**Special Council Meeting Agenda
Attachments**

AGENDA ITEM 4.1

**Re: Alterations & Additions -
Existing Supermarket at 18 Patrick St, Bothwell**

**Re: Planning Application RFI Response Dated 22 Dec -
Existing Supermarket at 18 Patrick St, Bothwell**

PROPOSED NORTH ELEVATION scale 1:100 @ A3

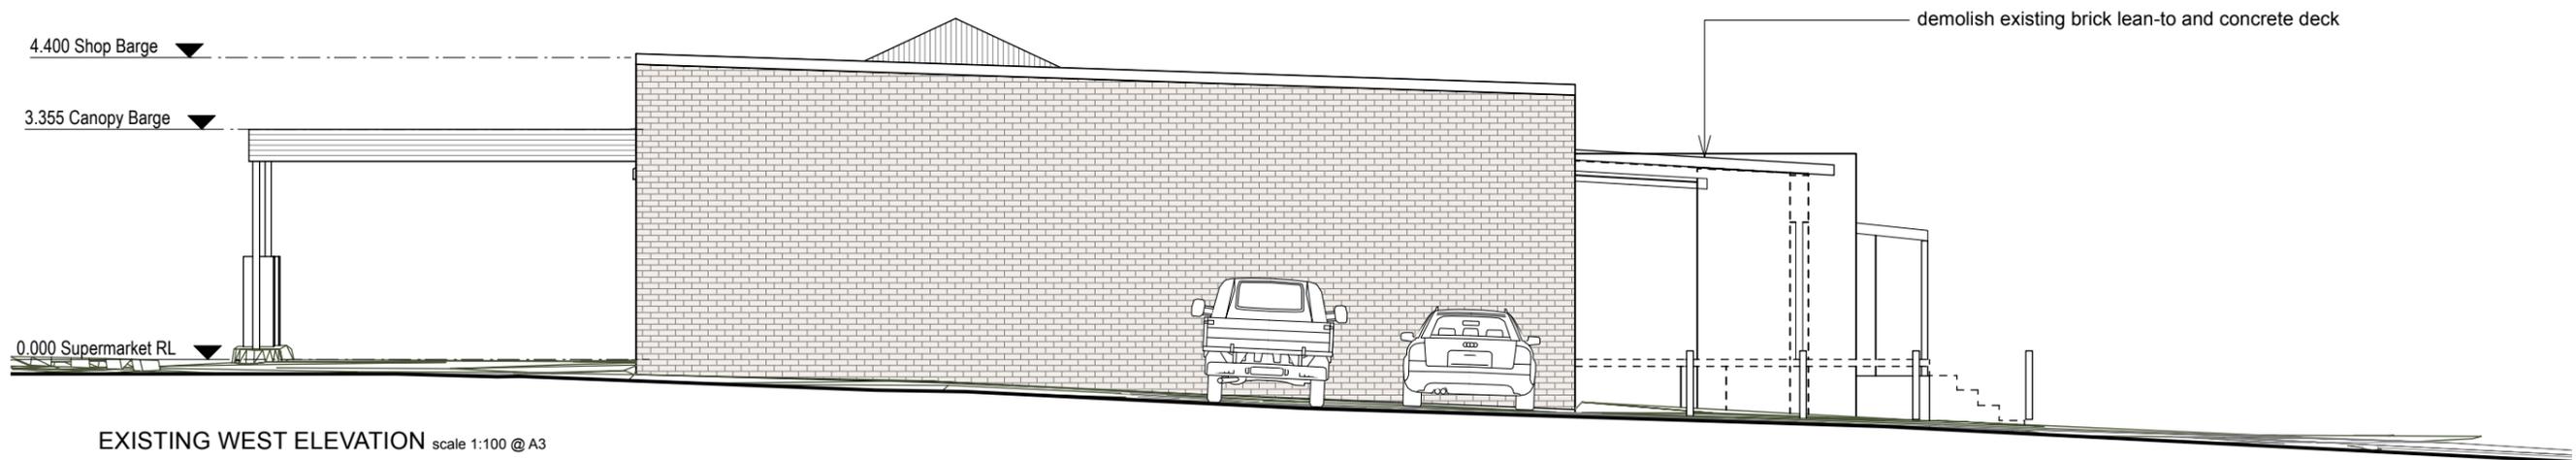
The forms of the proposed extensions are considered to be appropriate for the setting of the place and precinct. The more prominent storage shed/loading dock on Patrick Street has an appropriately pitched hipped roof form and utilises rough sawn cladding to part of the front elevation, which is appropriate to the heritage context and gives the building some subservience in materiality. It is recommended that as a condition of approval that the same cladding be utilised on the entire clad area of the northern wall and on the eastern wall of that extension, given the prominence of those elevations and that the proposed colourbond cladding is not considered appropriate in that context.

HER1. That the existing window aperture for the post office boxes on the northern elevation of the sandstone building is not to be enlarged and that the blocking of the adjacent door is to be undertaken with sandstone to match the surrounding wall.

HER2. That the cladding of the northern and eastern walls of the proposed store/loading area be timber (as per the proposed feature panel on the northern elevation).

PROPOSED WEST ELEVATION scale 1:100 @ A3

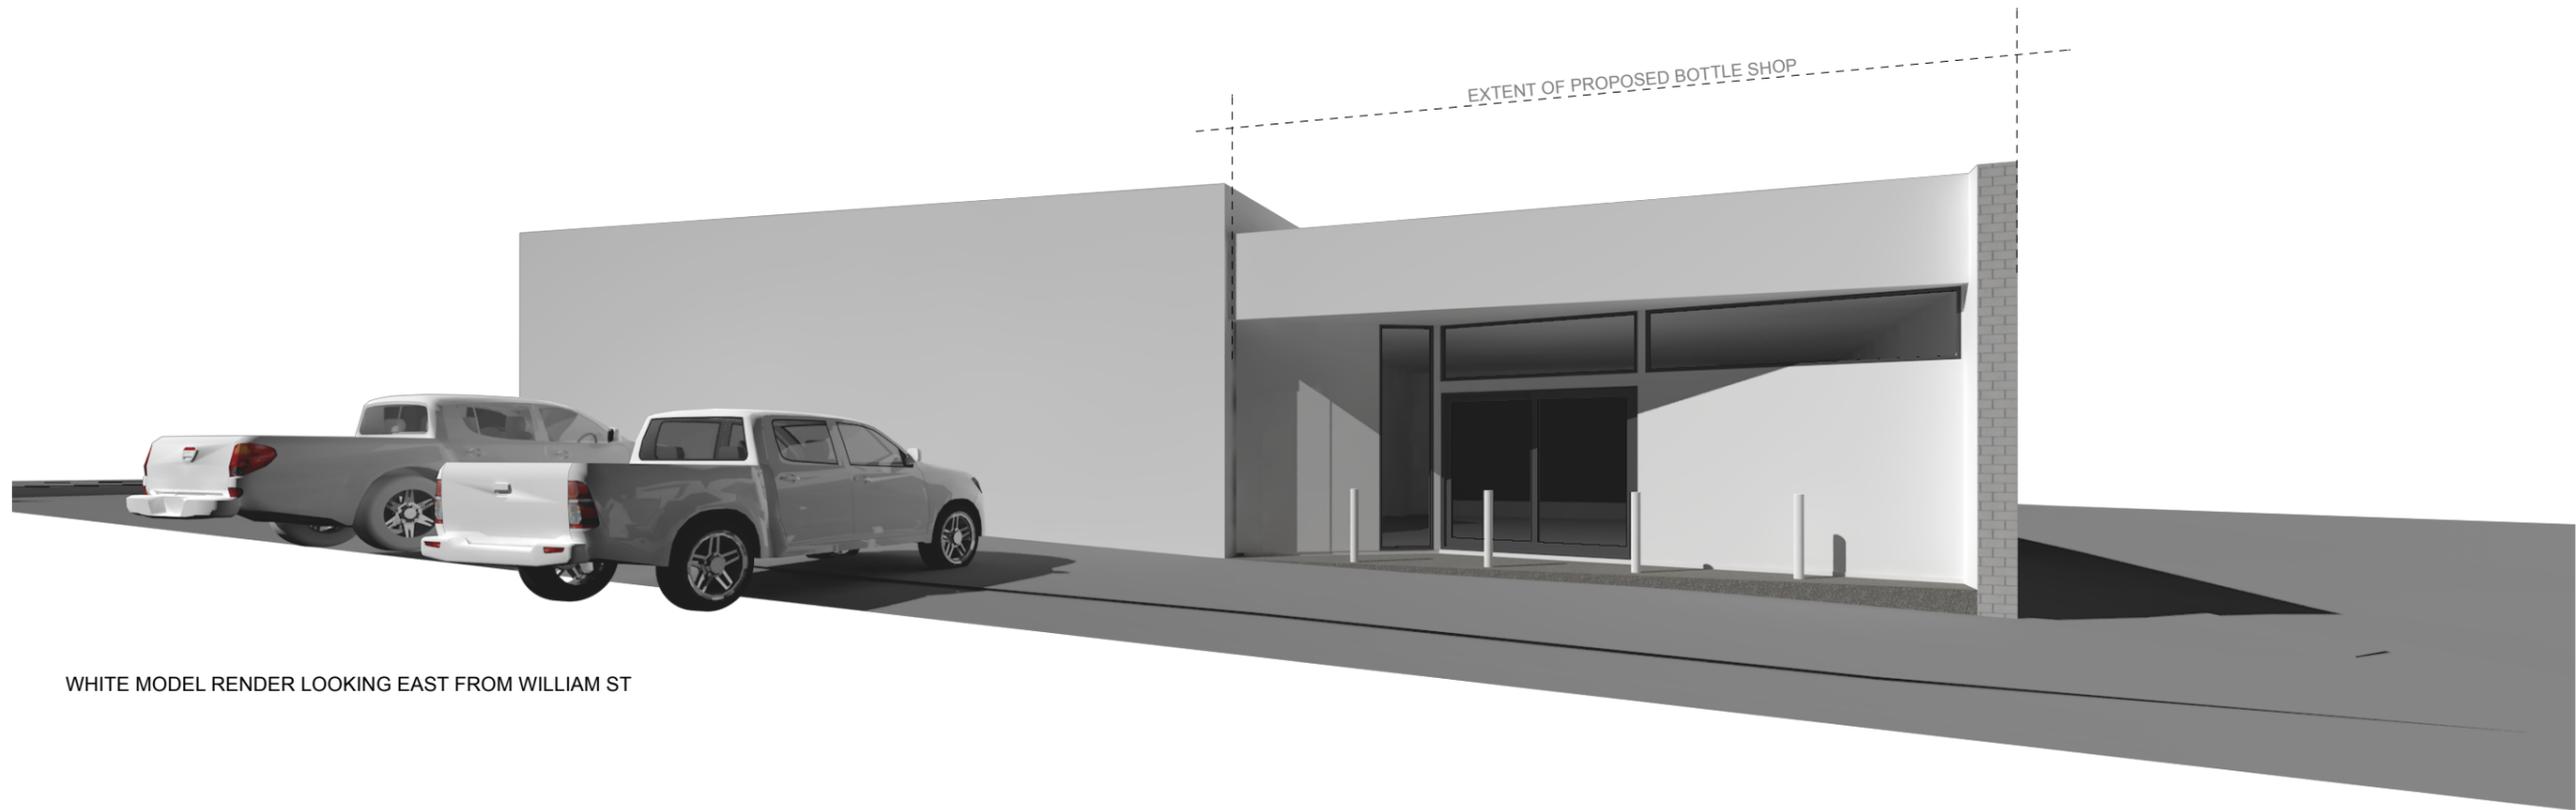
The rear bottle shop extension is not of a traditional form, with a low and flat roof, however this is not considered to be inappropriate as it provides more subservience within the complex and streetscape and is more appropriately presented as an ancillary building to the modern shop building, rather than attempting to emulate a heritage form. The construction is proposed to be concrete block, which is not considered to be an appropriate finish for that context – in particular the southern wall which is prominent on the approach along William Street. It is recommended that this wall be rendered, or an imitation sandstone block be used as a condition of any approval.

HER3. That the wall material on the western and southern walls of the proposed bottle shop extension be either imitation sandstone block or rendered concrete block.

PARKING DIAGRAM 21/01/25

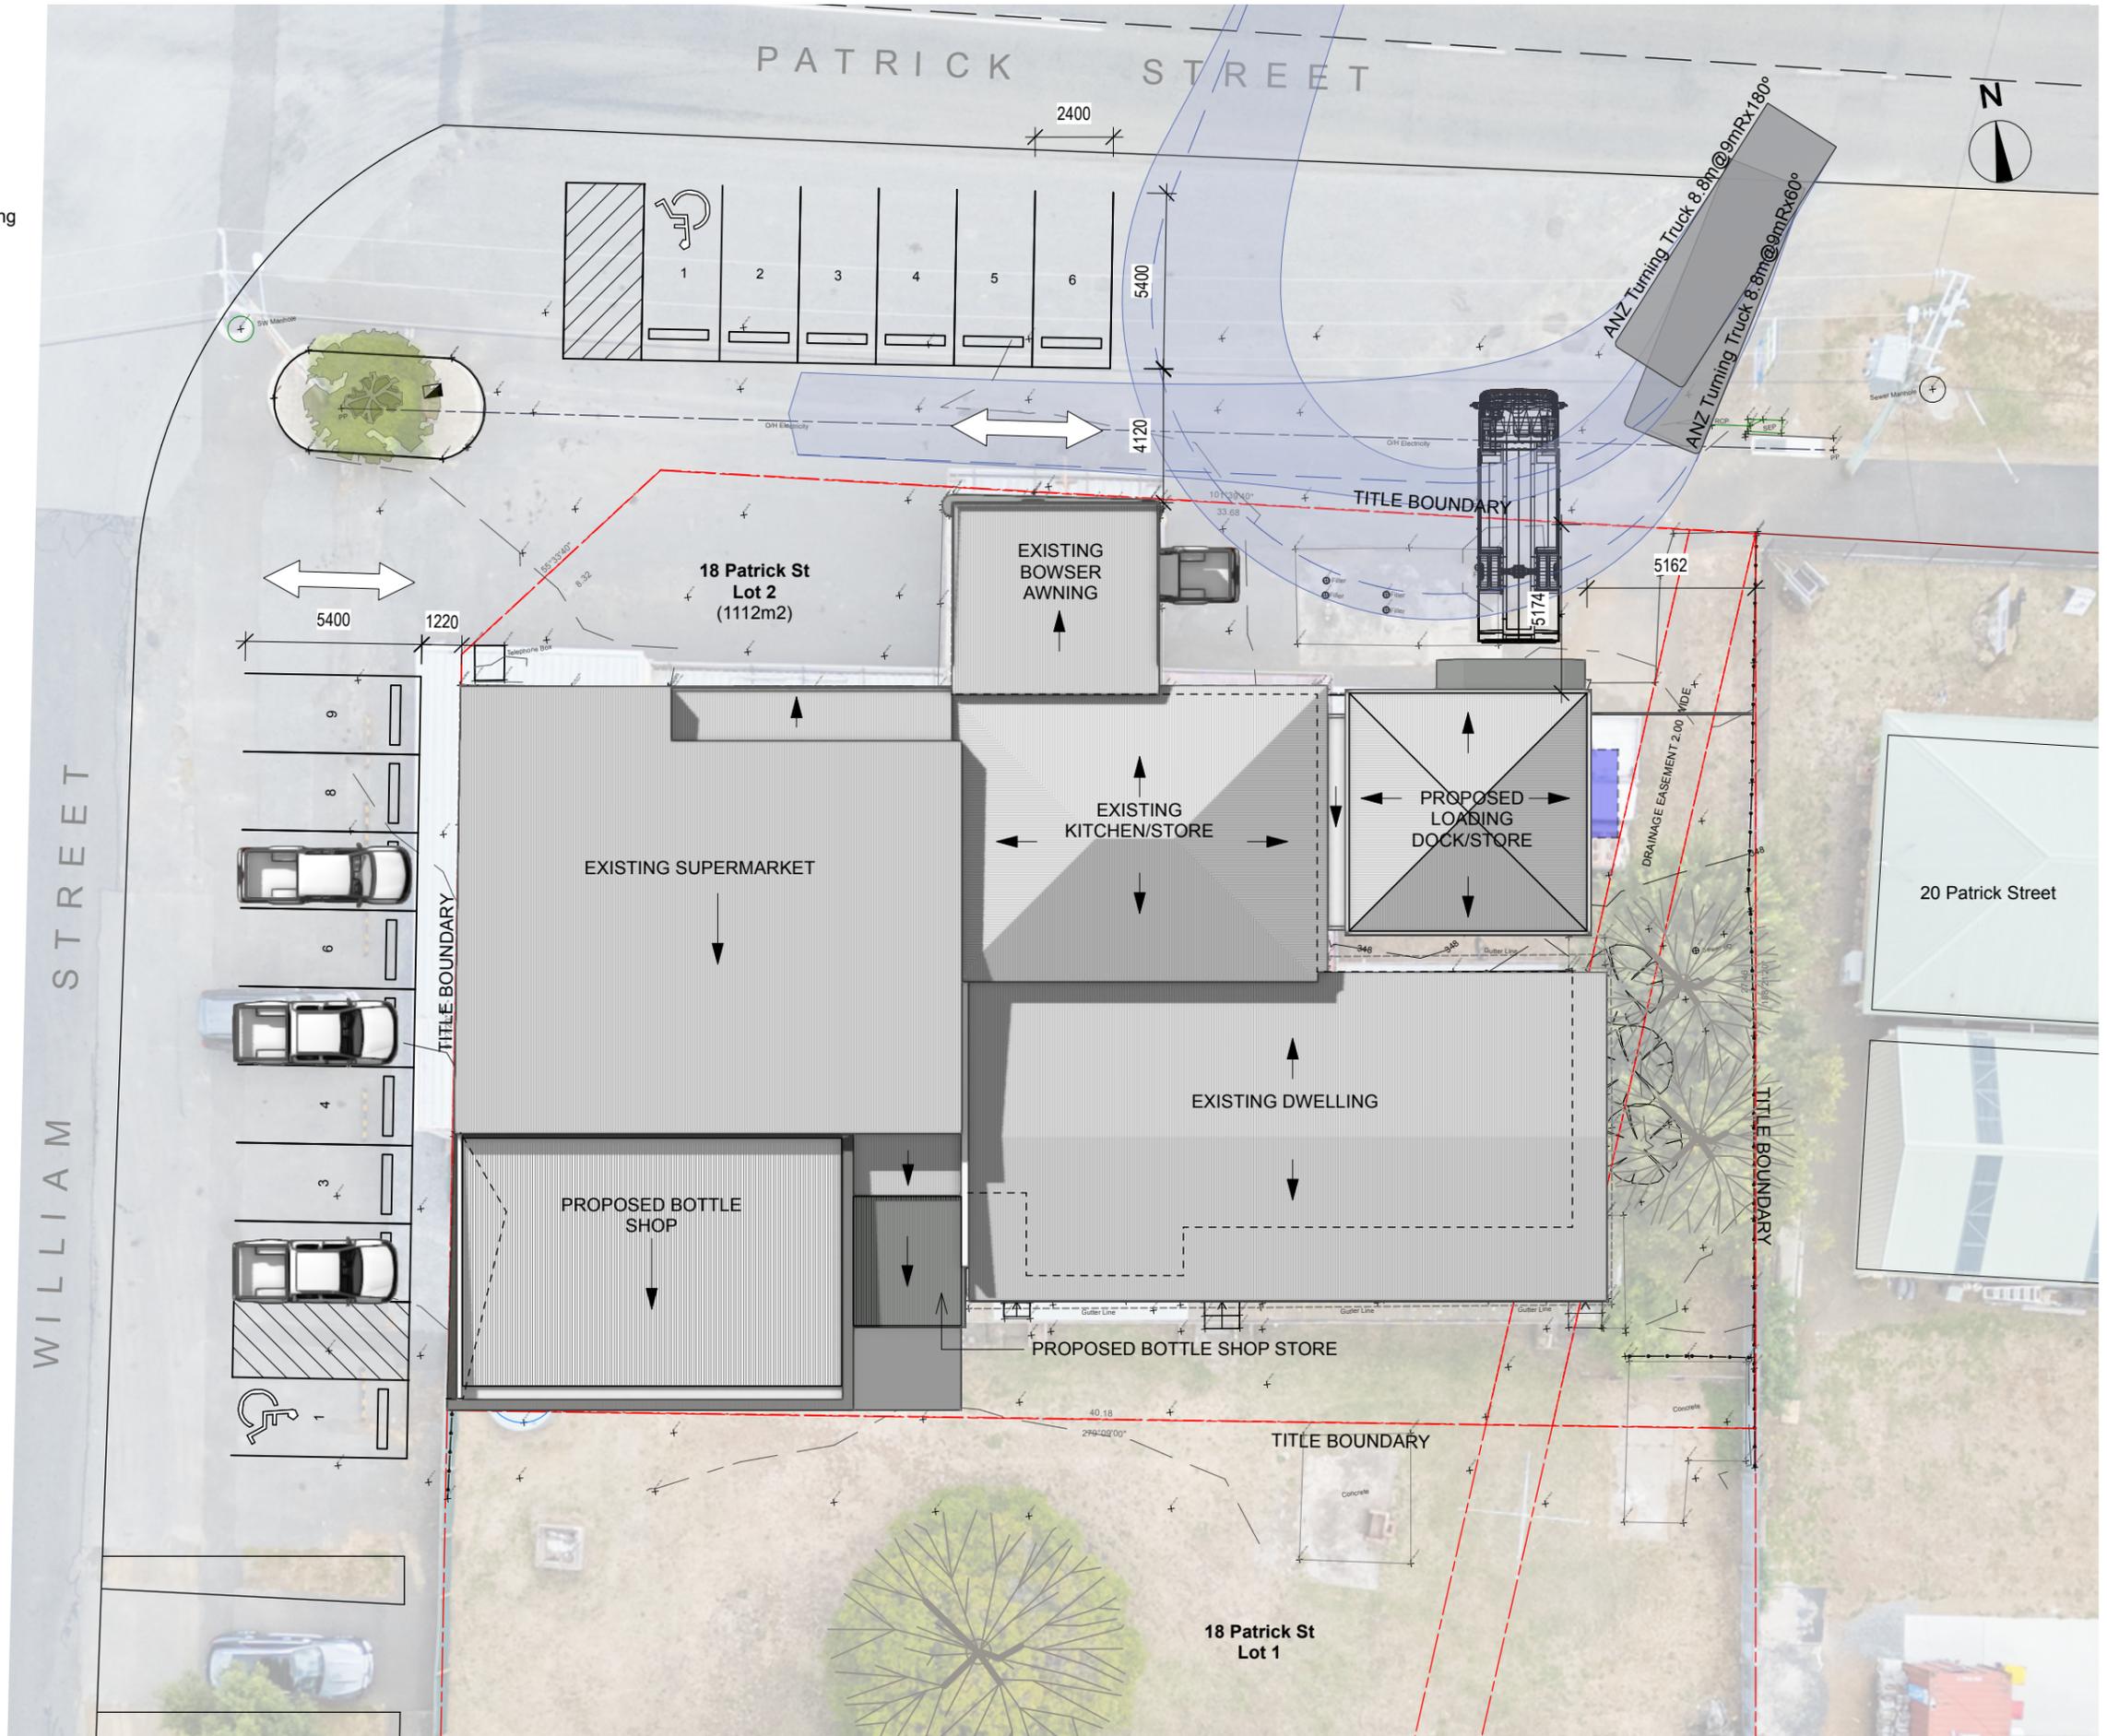
Please provide a written response to clause C2.5.1 Car parking numbers, A1 (d) and C2.6.1 Construction of parking areas A1 of the Code. Please provide a Parking Plan with the spaces allocated for the use, demarcated and Comply with Australian *Standard AS 2890- Parking facilities, Parts 1-6* and be designed and constructed in accordance with Australian/ New Zealand *Standard AS/NZS 2890.6:2009 Parking facilities, Off-street parking for people with disabilities.*

Please confirm that the loading bay meets the requirements of C2.6.6 Loading bays A1 and A2 or the Performance Criteria.

A total of 15 car parking spaces are required with one of these as an accessible parking space for each tenancy as per AS/NZS 2890.6:2009

Refer to the Parking Plan dated 21/01/25 for layouts. The layout provided demonstrates that the Acceptable solution for C2.5.1 can be satisfied.

The AS2890.2 Part 2 vehicle type for the loading dock area is classed as a Medium Rigid Vehicle MRV (8.8m). The turning circles for this vehicle are shown on the Parking Plan dated 21/01/2026. The diagram illustrated shows it meets or exceeds the standard listed above.

PARKING DIAGRAM 21/01/25

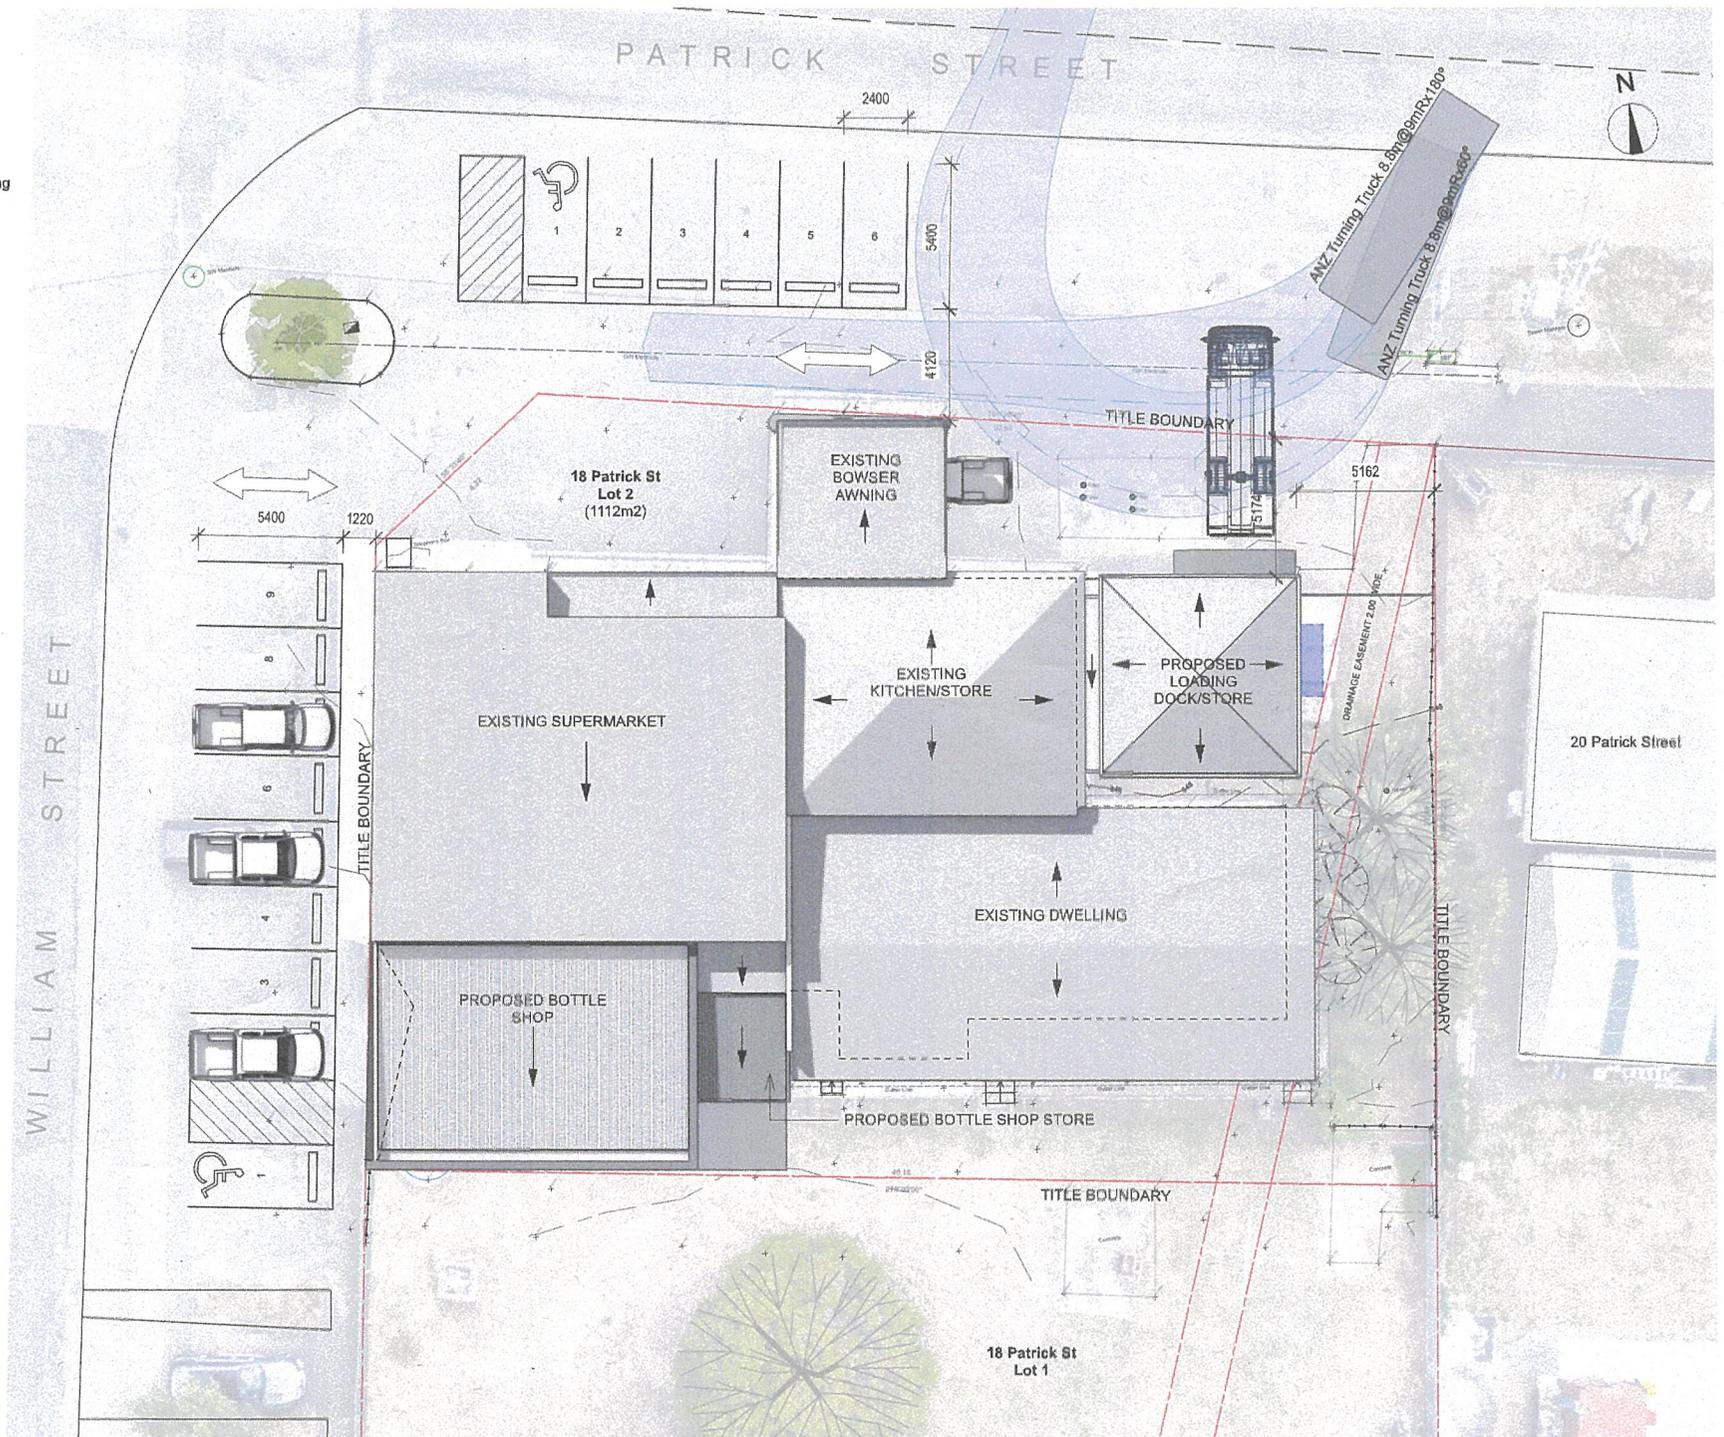
I notice there is designated parking across the front of the dwelling in Patrick St. and one is marked as Disabled Parking.

My concern is that the particular disabled spot marked, is at the end of a row of parking bays right near the corner of the intersection of Patrick and William Street. This is a very busy intersection with large machinery, trucks, caravans and more turning the corner to go into William Street. It is also at that intersection many caravans turn to go to the caravan park.

As we know, vehicles for the disabled are often larger to accommodate wheelchairs, walking assist items and more. To have a larger vehicle backing out of that spot right on the intersection may cause accidents or difficulties with large machinery negotiating turns. It is dangerous for all.

I do note that there is a disabled spot marked in William Street down near the bottle shop, but perhaps bay 6 could be adjusted to be for disabled as well (instead of the one in Patrick St) as it would be close to the store entrance and safer.

The parking bays at the front of the store mean that all the vehicles will need to back out into oncoming traffic. Would it be safer if the cars could drive forward to exit only into William Street where the vehicles could then safely turn left or right?
